**24 Mercer Street - Zoning Amendment Application -
Request for Direction Report**

Date:	August 8, 2012
To:	Toronto and East York Community Council
From:	Director, Community Planning, Toronto and East York District
Wards:	Ward 20 – Trinity-Spadina
Reference Number:	11 261965 STE 20 OZ

SUMMARY

Attachment 6: Site Plan

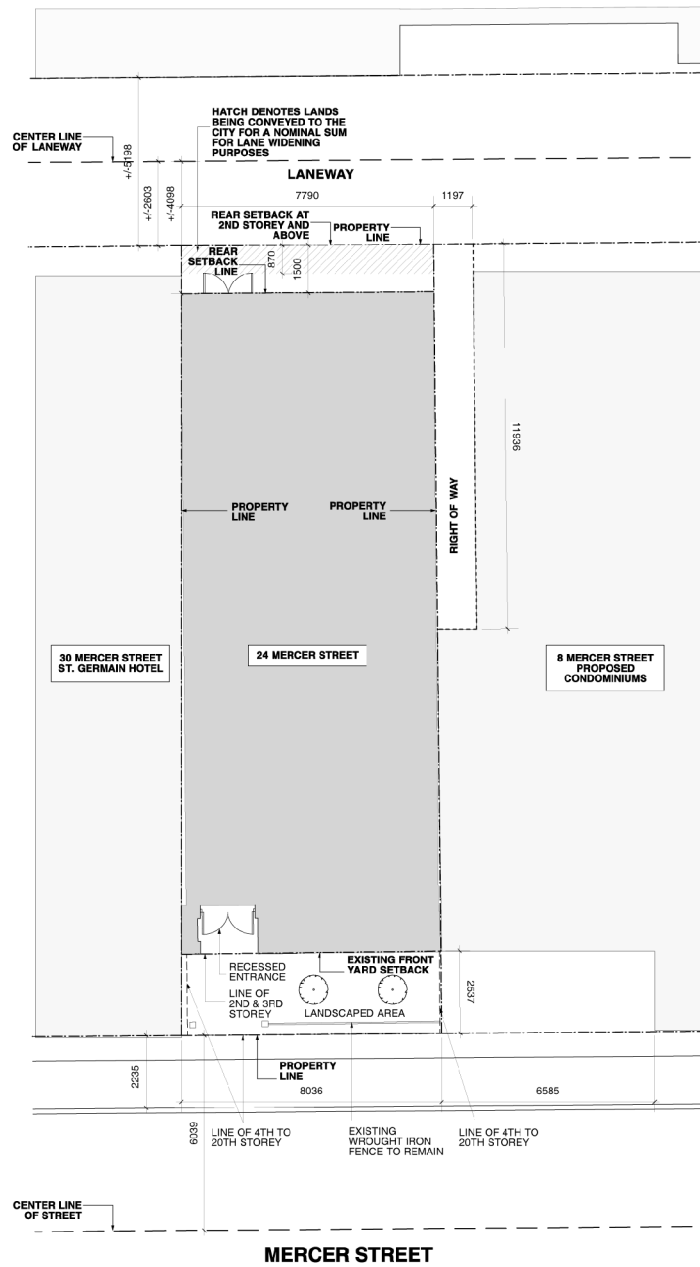
The applicant is required to provide a 0.87 metre laneway widening. The required laneway widening was not shown on earlier versions of the plan but the revised plans submitted by the applicant on August 13, 2012 do show the laneway widening and eliminate encroachments noted in earlier submissions.

Attachment 8: East and West Elevations

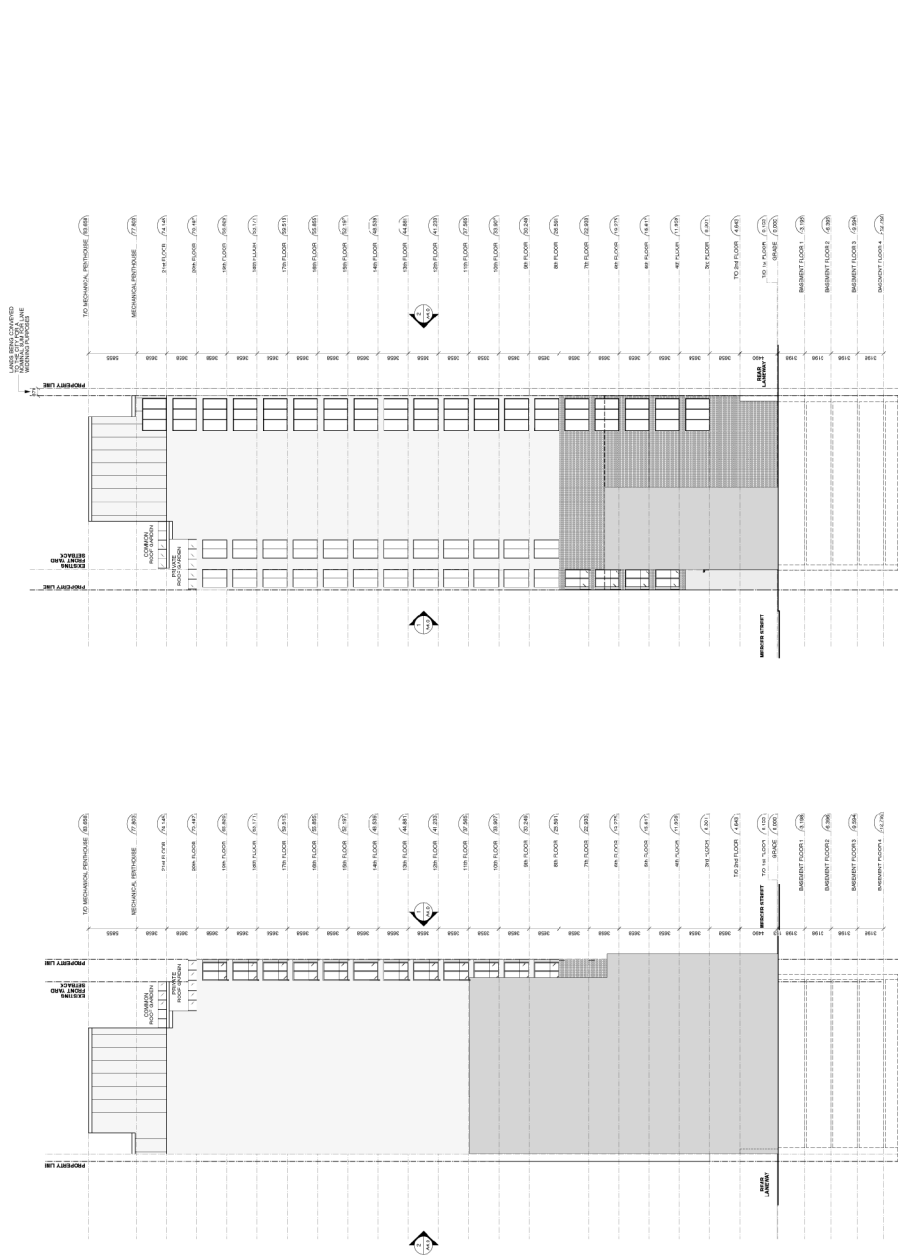
The distance between the applicants proposed tower and the 33-storey tower approved to the east of the site at 60 John Street and 12-18 Mercer Street (The Mercer) is 39 metres, or approximately 37.5 metres to the face of the western facing balconies. The applicant has submitted a limiting distance agreement with the owner of this property. This agreement is currently under review by City legal staff. A properly drafted limiting distance agreement and the existing site-specific zoning of The Mercer will prevent a tower being erected too close to the applicants proposed tower. The limiting distance agreement may (subject to review by Toronto Building staff) permit windows on the east elevation of the proposed tower, (see Attachment 8 - East and West Elevations).

The proposal will see the retention of the first two storeys of the south façade in its current location (set back approximately 2.5 metres from the front property line). What is proposed to be retained is insufficient. Heritage Preservation Services staff would typically require a substantial step back to allow the three-dimensional qualities of the original building to be retained. Instead of a step back the tower is proposed to cantilever over the heritage façade above the second storey. This will visually overshadow the retained portion of the heritage façade (see Attachment 8 – East and West Elevation).
